Product Safety Recall

N222383790 Seatbelt Pretensioner Fire

Release Date: January 2023

Revision: 01

6218989

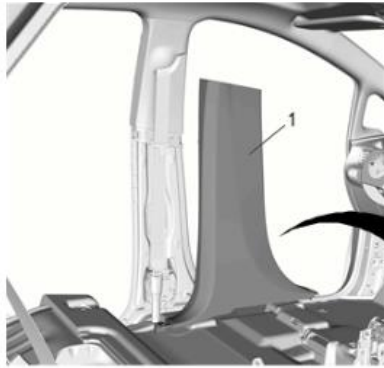
18. Pull the carpet back around the seat belt pretensioner to expose the insulation on the passenger's side of the vehicle.
19. Cut insulation to be the same dimension as the existing hole for the cable (25 mm, 1 inch) as shown above.

5443038

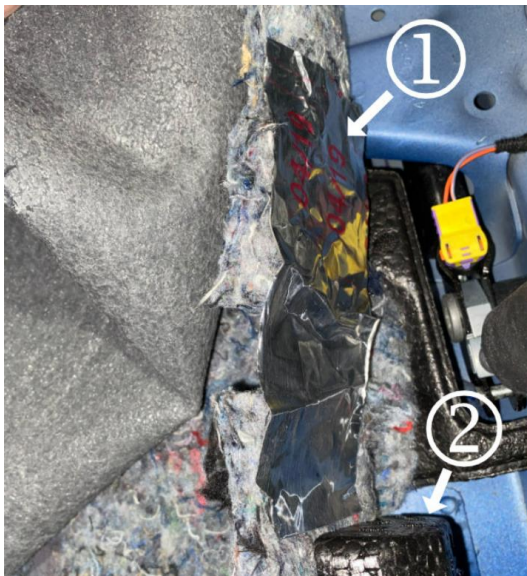
20. Prepare two 150 mm (6 in) pieces of 3-M PN 3340 foil tape of an equivalent 2.5" X 4.0 Mil aluminum foil tape meeting UL Spec 181A-P.

6219007

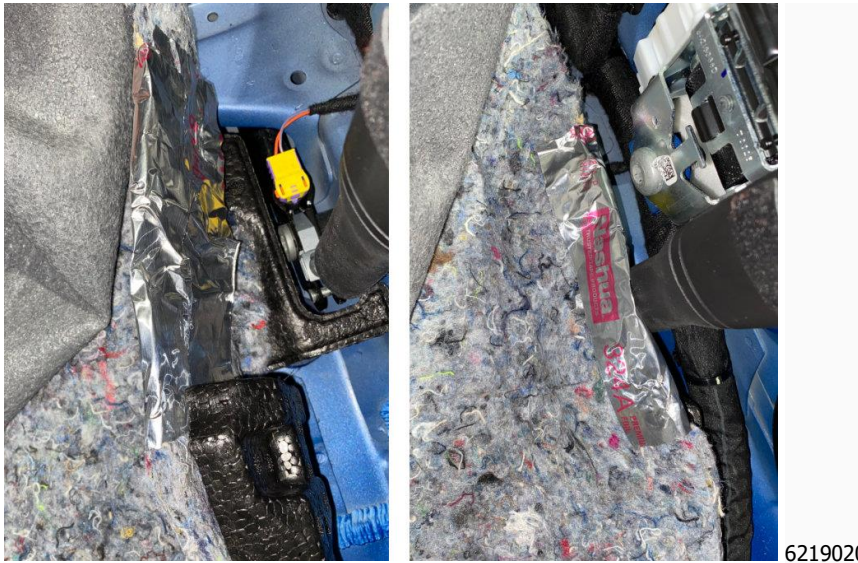
21. Place one of the pieces of foil tape (1) along the bottom of the insulation starting from the foam block (2) and going forward lining up with the edge of the insulation, as shown above.

22. Place the second piece of foil tape on top of the insulation lining it up with bottom piece of tape leaving about half the width of the tape hanging off the edge of the insulation.
23. Carefully fold the tape over the edge of the insulation and ensure it fully adheres to the bottom piece of tape as shown above.

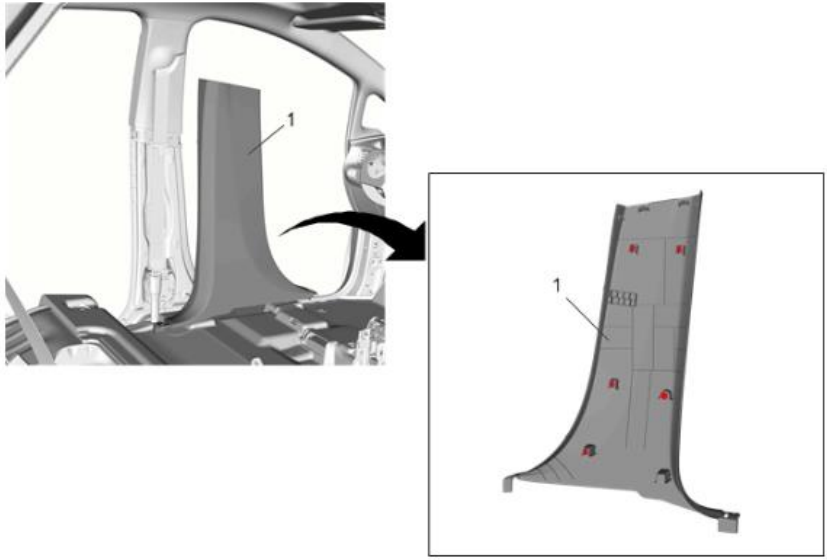
24. Cut a slit lining up with the seat belt pretensioner in both pieces of tape to allow the insulation and tape to fit around the pretensioner as shown above.
25. Reinstall the insulation into its original location.
26. Fold carpet back into place.
27. Repeat steps 18 through 26 on the driver's side of the vehicle.
